V2500-A1/A5/D5 SERIES PROPULSION SYSTEM SERVICE BULLETIN

This document transmits Revision 1 to Service Bulletin V2500-ENG-70-0832 and Revision 1 of the Supplement

V2500-ENG-70-0832

INFORMATION – ELECTRONIC ENGINE CONTROL (EEC) – FLAME SHIELD REMOVAL FOR EEC150-1 AND
EEC150-20

EEC WITH FLAME SHIELDS AND EEC WITHOUT FLAME SHIELDS
Figure 1

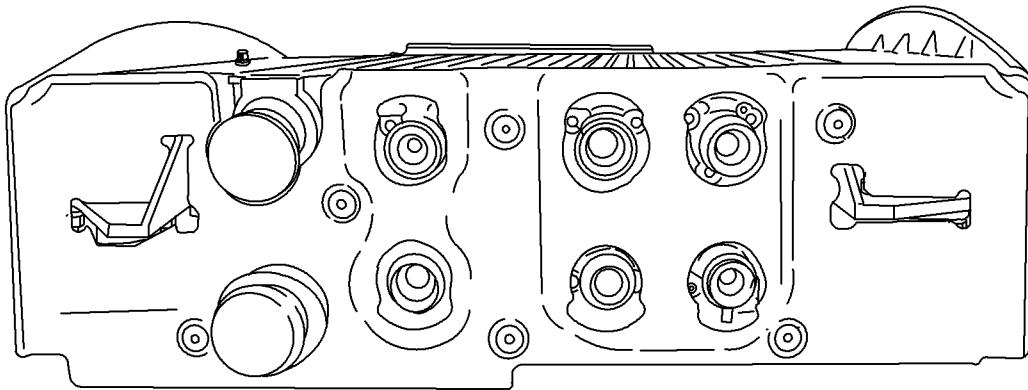
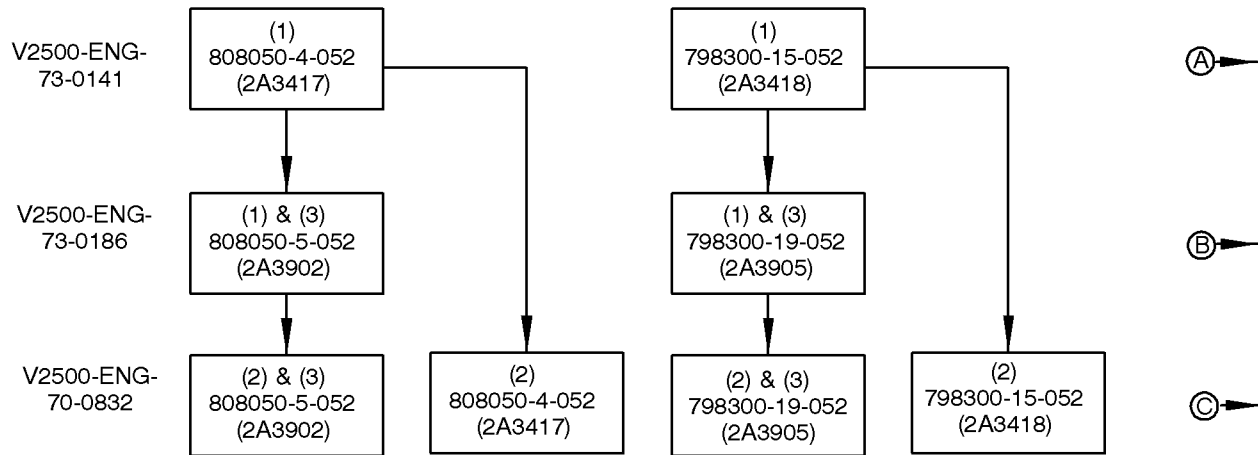
- (1) Problem: On the Listed Electronic Engine Control (EEC) source control drawings, advance the vendor drawing revision letter to reflect a supplier change in which the flame shields are being removed from the EEC's.
- (2) Evidence: The flame shields have a tendency to crack, and the repair and/or replacement of the shields has become a financial burden to airline customers. The EEC's have demonstrated successful operation without the flame shields during fire test.
- (3) Objective: Provide EEC's without flame shields to reduce the financial burden to airline customers.
- (4) Substantiation: The 2 EEC'S affected are EEC150-1 and EEC150-20. A fire test was performed to demonstrate the fire resistance of the EEC without the Flame Shield.
- (5) Effects of Bulletin on:

Although the part number has not been changed, there is a physical difference in the appearance between the EEC with flame shields verses the EEC without flame shields. See Figure 1.

Provide an EEC with flameshields removed.

FAMILY TREE – A1 EEC. REFERENCE CATALOG SEQUENCE NUMBER 73-22-34. FIGURE 1 ITEM 280.
Chart A (Sheet 1)

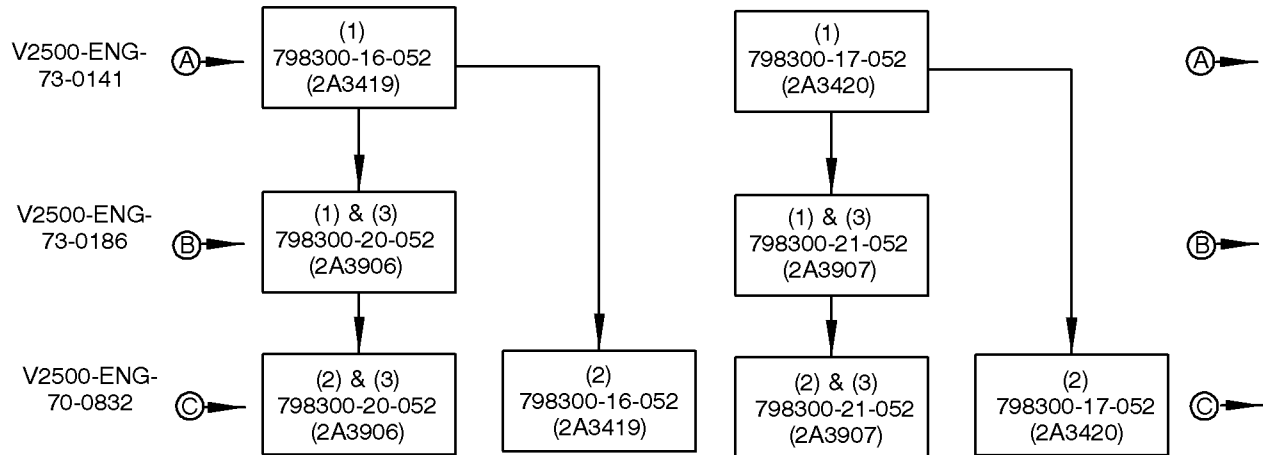
- (1) WITH FLAME SHIELDS
- (2) WITHOUT FLAME SHIELDS
- (3) PB SCREEN DELETED

FAMILY TREE - A1 EEC. REFERENCE CATALOG SEQUENCE NUMBER 73-22-34. FIGURE 1 ITEM 280.
Chart A (Sheet 2)

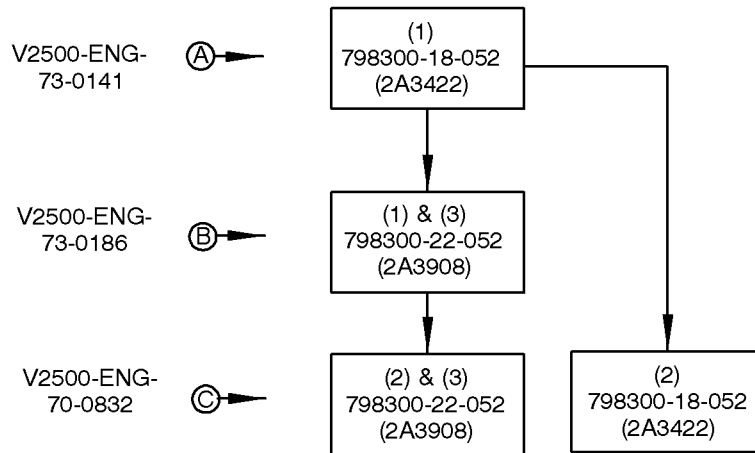
- (1) WITH FLAME SHIELDS
- (2) WITHOUT FLAME SHIELDS
- (3) PB SCREEN DELETED

FAMILY TREE – A1 EEC. REFERENCE CATALOG SEQUENCE NUMBER 73-22-34. FIGURE 1 ITEM 280.
Chart A (Sheet 3)

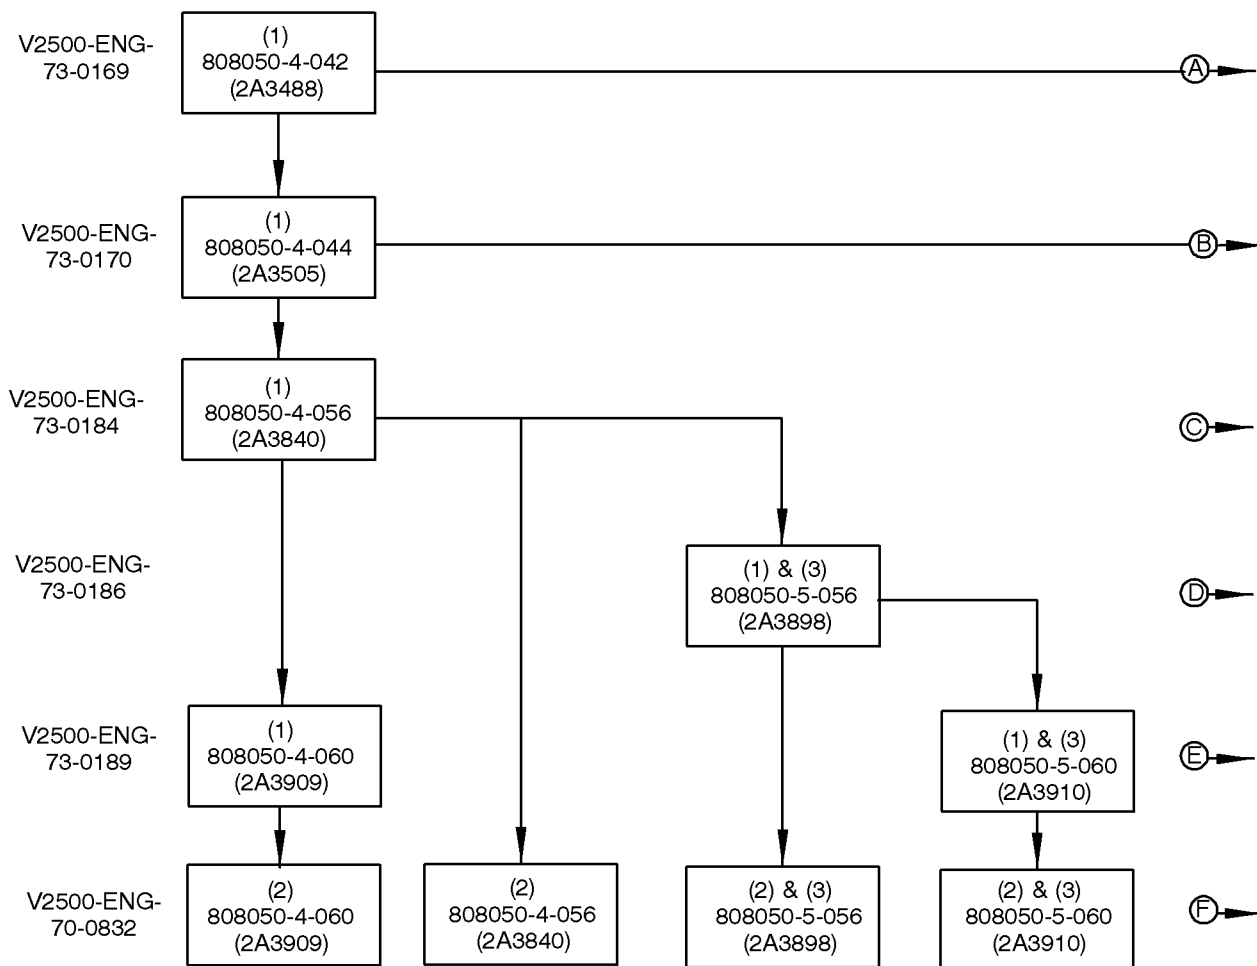
- (1) WITH FLAME SHIELDS
- (2) WITHOUT FLAME SHIELDS
- (3) PB SCREEN DELETED

FAMILY TREE - A5 EEC. REFERENCE CATALOG SEQUENCE NUMBER 73-22-34. FIGURE 1 ITEM 280.
Chart B (Sheet 1)

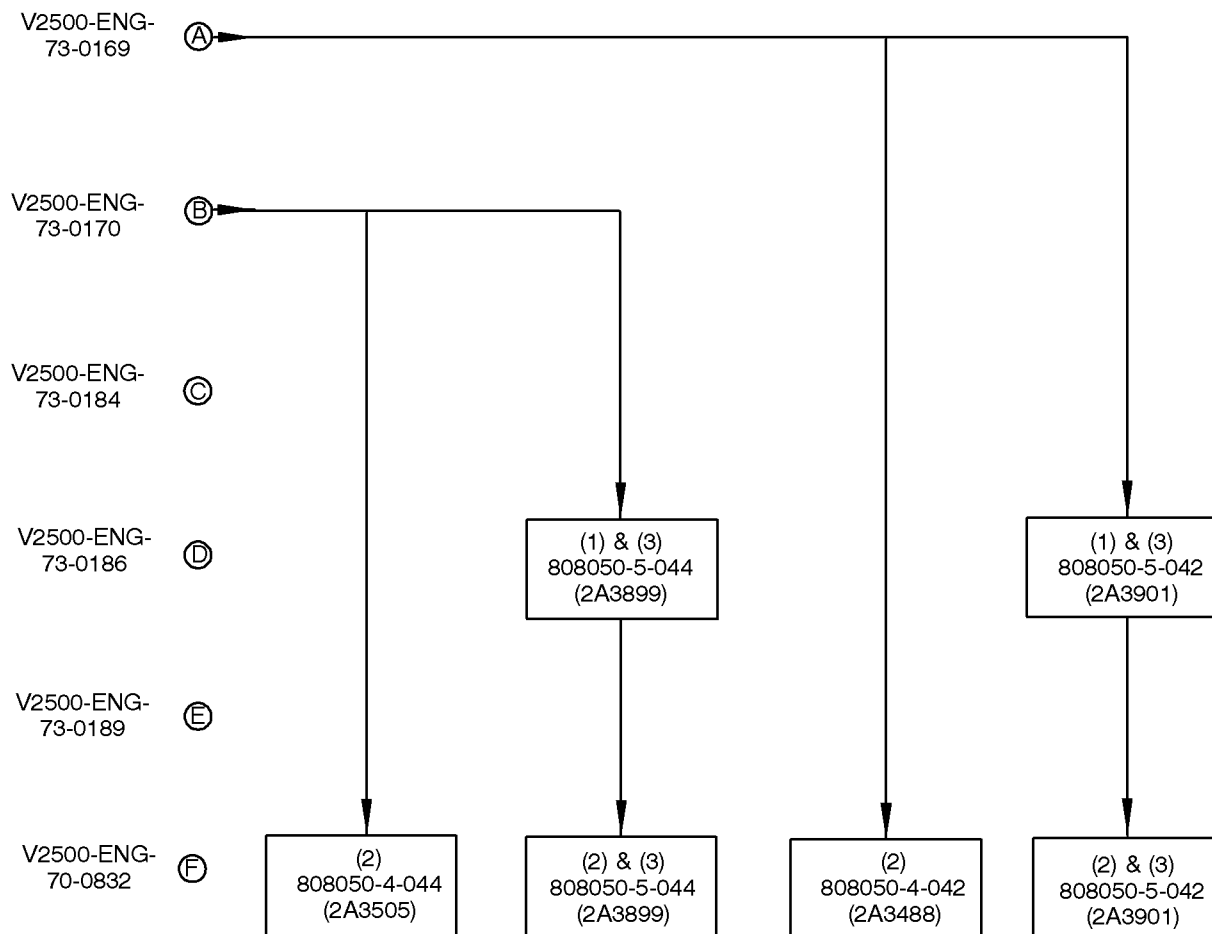
- (1) WITH FLAME SHIELDS
- (2) WITHOUT FLAME SHIELDS
- (3) PB SCREEN DELETED

FAMILY TREE – A5 EEC. REFERENCE CATALOG SEQUENCE NUMBER 73-22-34. FIGURE 1 ITEM 280.
Chart B (Sheet 2)

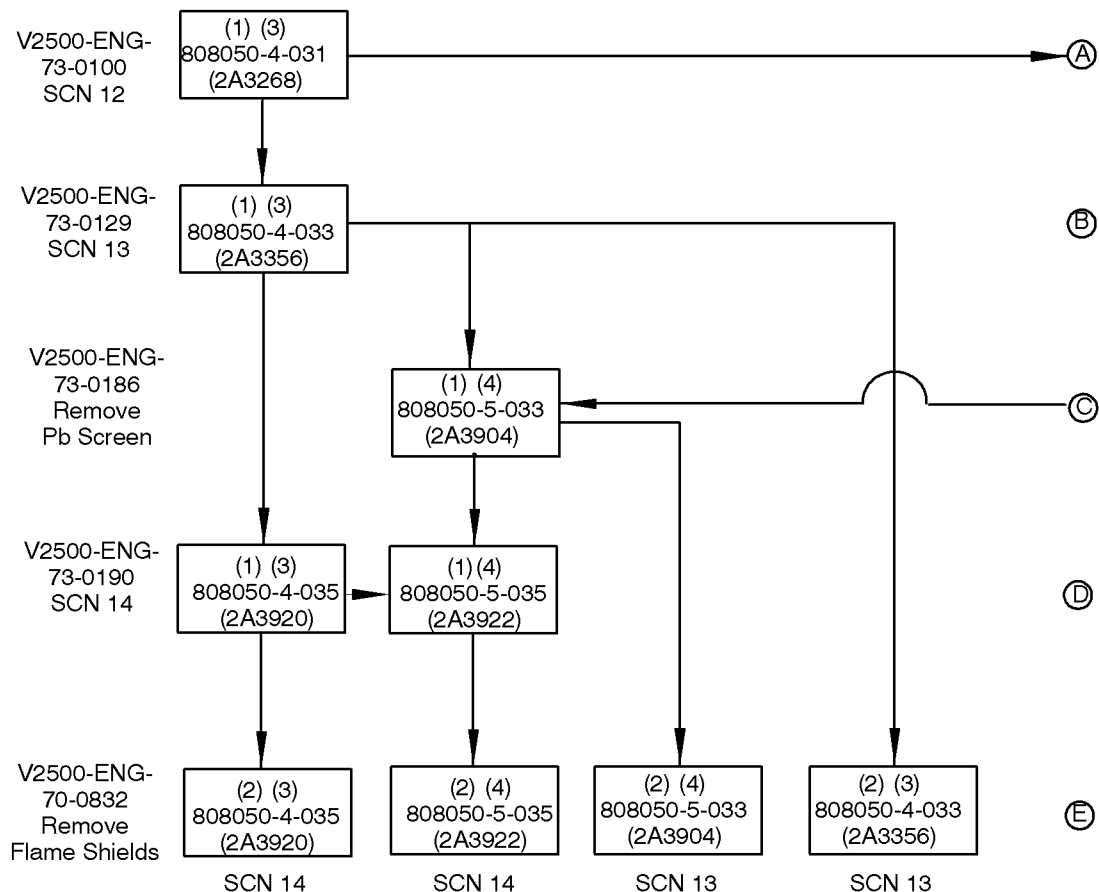
- (1) WITH FLAME SHIELDS
- (2) WITHOUT FLAME SHIELDS
- (3) PB SCREEN DELETED

R FAMILY TREE D5 EEC. REFERENCE CATALOG SEQUENCE NUMBER 73-22-34. FIGURE 1 ITEM 280.
R CHART C (Sheet 1)

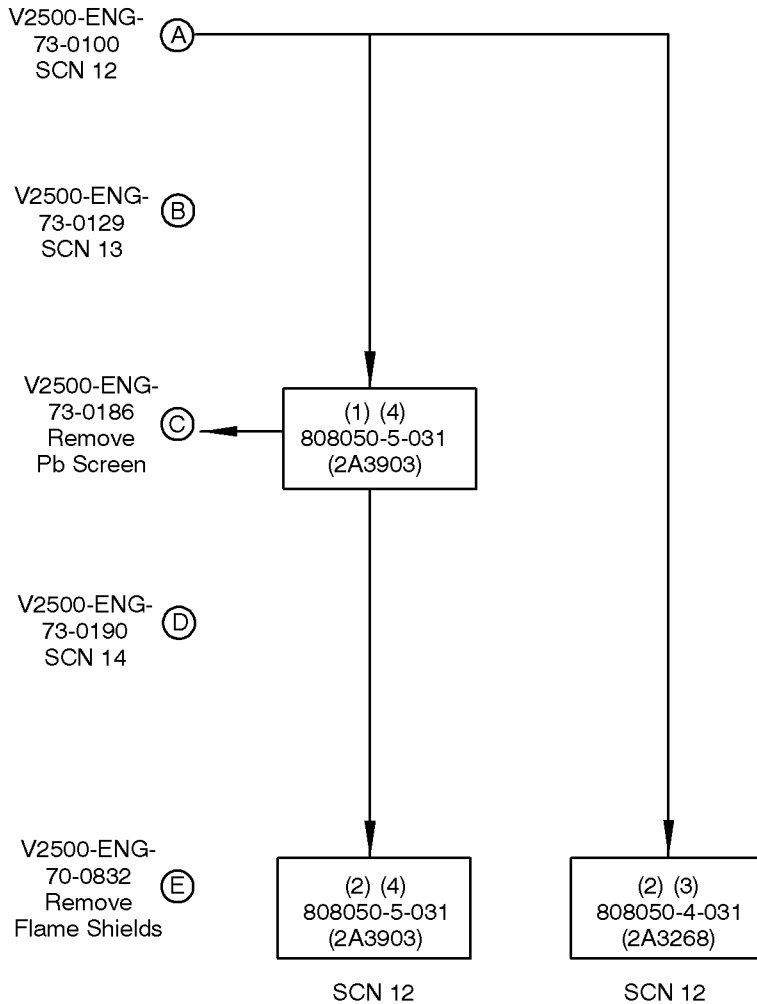
- (1) WITH HEAT SHIELDS
- (2) WITHOUT HEATSHIELDS
- (3) WITH PB SCREEN
- (4) PB SCREEN DELETED
